Re: Environmental Defense Center Comments on Proposed Cabrillo Port Air Permit

BHP Billiton LNG International, Inc ("BHP") has reviewed the August 2, 2006 comment letter prepared by the Environmental Defense Center ("EDC") (the "EDC letter") and its two primary attachments, the July 31, 2006 letter from Powers Engineering (the "Powers letter") and the July 26, 2006 letter from Camille Sears (the "Sears letter"). The EDC letter was submitted to the U.S. Environmental Protection Agency ("EPA") regarding the draft Cabrillo Port Authority to Construct ("ATC") which would authorize construction of those portions of the project defined as the "stationary source". The EDC letter, the Powers letter and the Sears letter contain several legitimate questions that we attempt to answer as completely as possible. The letters also contain multiple erroneous statements regarding Cabrillo Port that we have endeavored to correct. In sum, this letter identifies each of the comments made in the EDC letter, the Powers letter and the Sears letter and provides a point-by-point response. Because the EDC letter repeats many of the points made in the Powers letter and Sears letter, we begin with those two

SCVs Shown in Relation to SCRs (4 out of 8 SCVs shown)

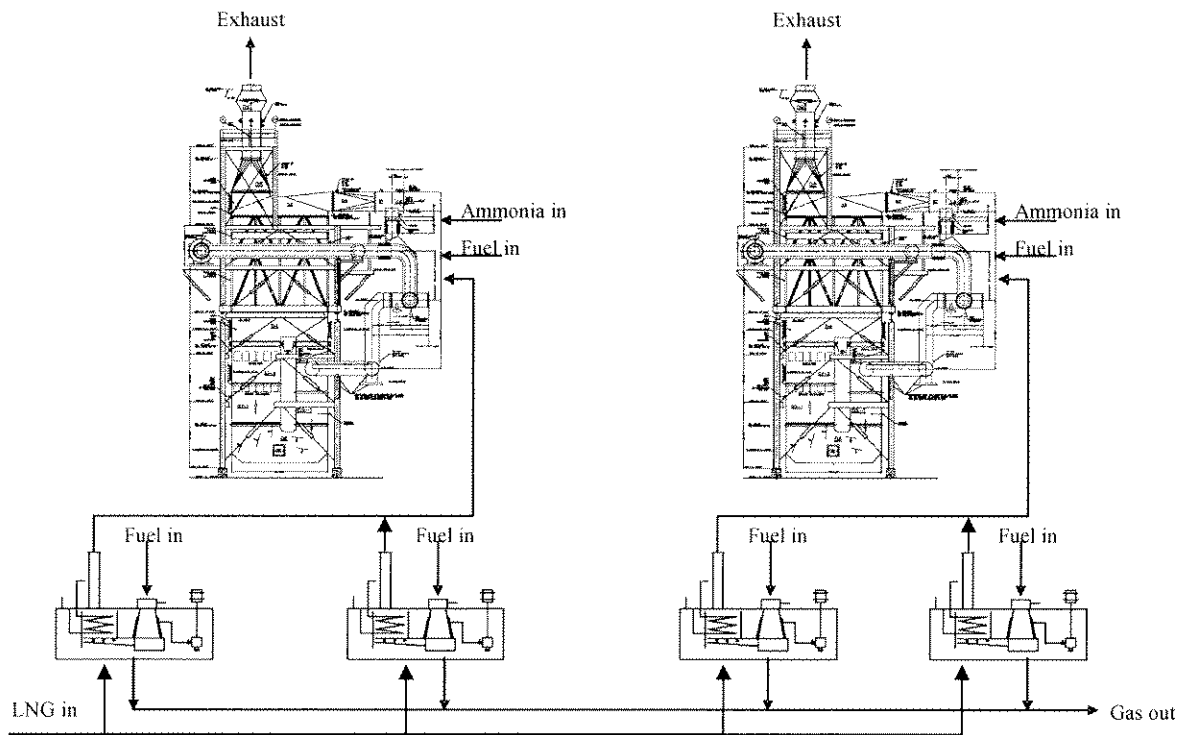
Mr. Powers goes on to wrongly suggest that an SCR system could be placed on the FSRU along with the duct burners necessary to warm the exhaust stream up to the temperatures necessary to support the catalytic reaction process. This statement is also misleading. The shell and tube systems such as those proposed for the Neptune Suez and Northeast Gateway projects rely on ship boilers for steam and electricity generation. Similar to the internal combustion engines proposed for Cabrillo Port's power generation, SCR is readily adaptable to the high temperature emissions discharge from a marine boiler. However, that does not mean that the technology can be moved over for use in the fundamentally different exhaust stream from the SCVs. A key advantage of SCV is its very high heat transfer efficiency, estimated at slightly higher than 98 percent. This means that a single SCV with a heat input of 115 MMBtu/hr transfers 112.7 MMBtu/hr to vaporize LNG. This high efficiency minimizes emissions of the greenhouse gas carbon dioxide, since a minimum amount of fuel gas is burned. However it also means that there is no residual heat. As SCR requires the exhaust gas to be at 600 – 650 °F, this means that you need to then burn a large amount of gas to make up for the thermal efficiency of the SCVs and move the exhaust gas back to the required temperature for the controls to work.

BHP's engineers carefully considered the duct burner option. Many physical, technical, and cost problems were identified by BHP's engineers after discussions with both the owner and the contractors for the one onshore facility utilizing SCR on SCVs. Based on this evaluation, included as an attachment to this letter, BHP's engineers concluded that SCR is not a technically feasible or demonstrated technology. In addition, the use of duct burners to reheat the cold (70 – 80 °F) SCV exhaust to 600 – 650 °F at the SCR inlet would increase greenhouse gas emissions from the FSRU. Using SCV exhaust gas physical properties from Selas specifications and assuming 85% recuperative heat recovery, a quick calculation shows that four (4) SCVs operating continuously would require an estimated duct burner heat input of about 12 MMBtu/hr (which is higher than the 4 to 5 MMBtu/hr estimated in the comment letter), or about 104 mmcf/yr fuel gas. This would result in an additional 6,260 tons per year of carbon dioxide and about 4 tons per year of additional carbon monoxide emissions (using AP-42 emission factors). The overall effect would be to increase SCV fuel gas consumption by about 2.6%. Therefore, this option of using duct burner technology was not considered appropriate by BHP's process engineers or by EPA.

As the permitting record reflects, BHP and EPA had extensive discussion over the possibility of utilizing SCR on the SCVs. The primary concerns were the size of the unit necessary to control the SCVs and the uncertainty of how such a large unit would work in a marine environment. Mr. Powers cavalierly suggests that two gas-gas heat exchanger/SCR systems could be mounted above the SCVs on the FSRU. However, this comment reflects a profound lack of appreciation of the nature of a marine source. Any addition of topside weight to the FSRU has serious ramifications for the safety of the facility as it increases the tendency of the FSRU to roll in heavy seas. The size of the units necessary for the volume of exhaust gas coming from the SCVs was determined by BHP's engineers and drawings prepared to provide a sense of scale. These drawings (submitted to EPA in May 2005) are reproduced below.

In order to develop a system consistent with Mr. Powers design BHP would essentially need to convert to a shell and tube system such as that proposed by Neptune Suez and Northeast Gateway. However, as noted above, shell and tube vaporization technology is between 5 and 10 times less efficient than the SCV technology proposed by BHP. As a result, the emissions, even with SCR, are well in excess of those from BHP's proposed technology. Combined with all of the other issues associated with adapting SCR to a marine application, there is no basis for concluding SCR is appropriate for Cabrillo Port.
